A.E.CO. TYPE 85A TELEPHONE SET  
MODIFICATION FOR USE IN 10A1, 10A2 AND 16A KEY TELEPHONE SYSTEMS

1.01 This addendum is issued to add information concerning modification of NC-series Type 85A instruments to that appearing for NB- and prior series sets in Section 473-502-800, Issue 1.

Figure 4. Wiring Diagram of Modified NC-Series Type 85A Telephone Set.

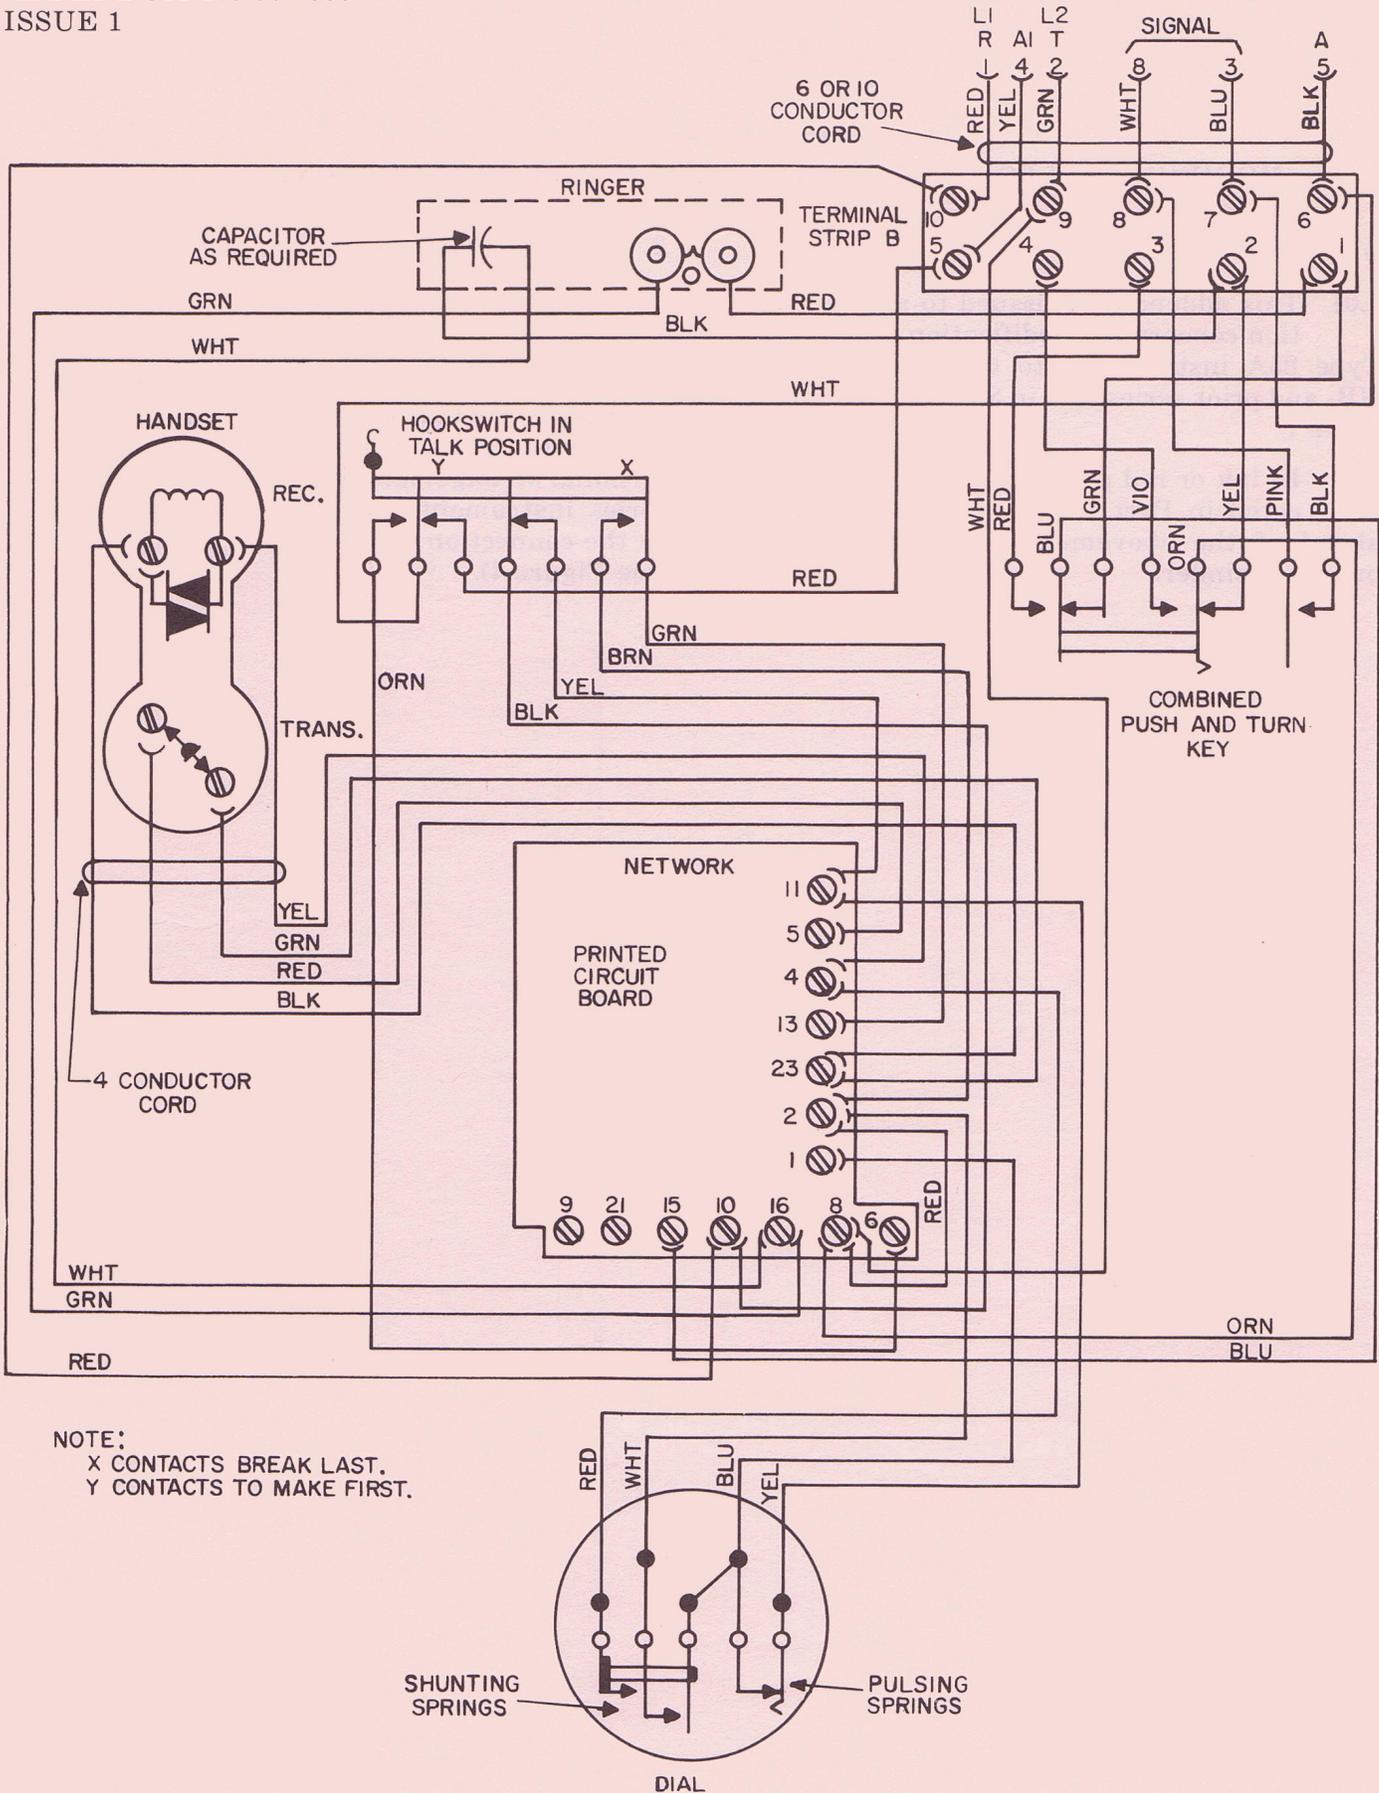
2.01 Adjacent to step (3) in Paragraph 2.01, enter the notation "See Addendum". NC-series telephone sets use a hookswitch assembly with an individual lead per spring, and a network which lacks terminal 7 and has a different terminal arrangement. When converting an NC-series instrument, eliminate steps (3) and (4), as the connection is provided by factory wiring (see Figure 4).
